SS 1034492 New Cascadia P4 Coolant Level Wiring Damage

This solution was updated on 5/31/2020 to reflect the most recent routing.

All New Cascadia P4 Vehicles manufactured before September 2019

Picture of areas to check for damaged wires Figure 1

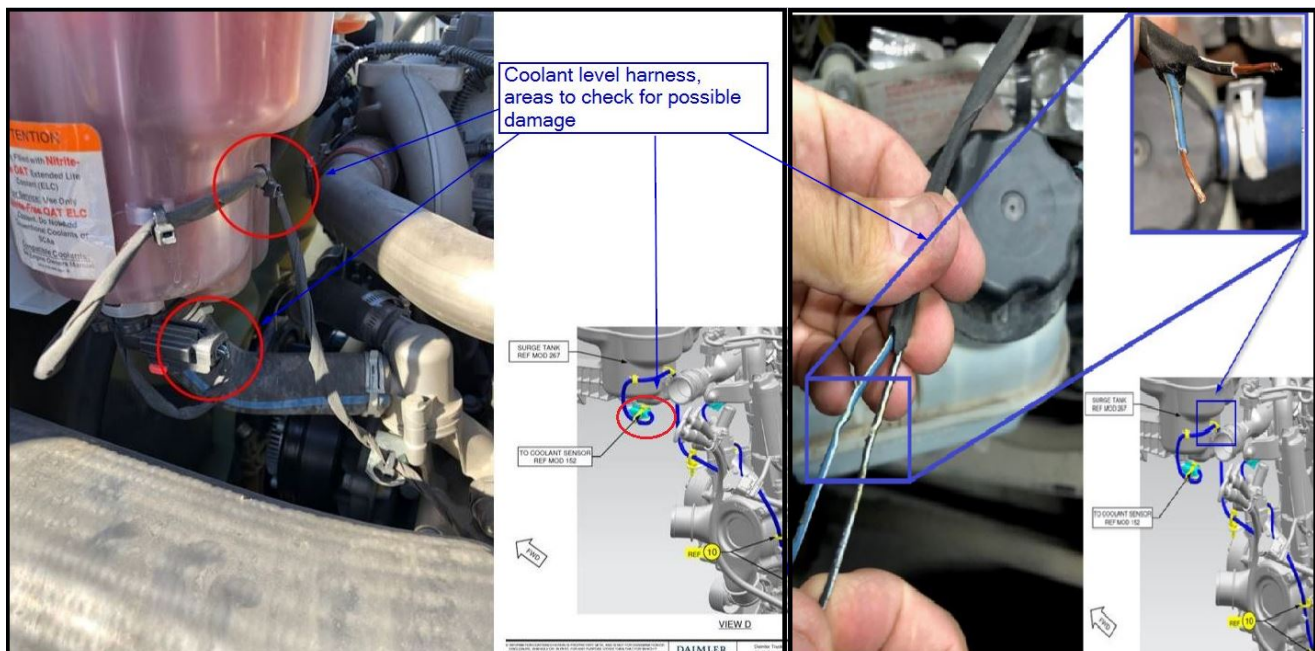
Depending on the tension applied to the wiring located at the coolant level sensor and its mounting locations, wiring damage can occur, resulting in one or more of the above listed codes becoming active. See figure 1 for areas of concern pertaining to the coolant level harness routing.

Cummins routing original vs new Figure 2

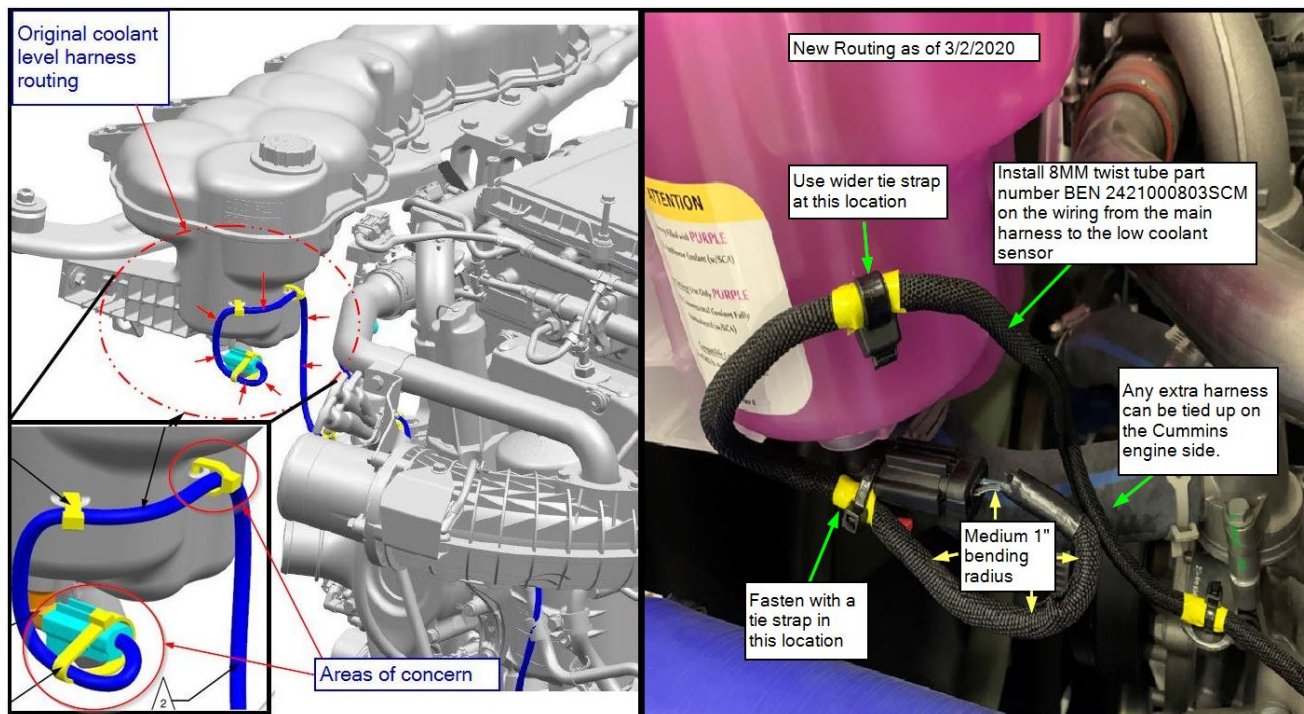
If the coolant level sensor harness is damaged, reference Freightliner Service Bulletin 54-290 for proper repairing of the harness. Once repairs are made to the harness, make sure that harness is properly wrapped with 8MM Twist Tube P/N BEN 2421000803SCM protecting the wiring. Route the wiring for HDEP engines referencing the new routing in figure 3 below and for Cummins engines reference figure 2.
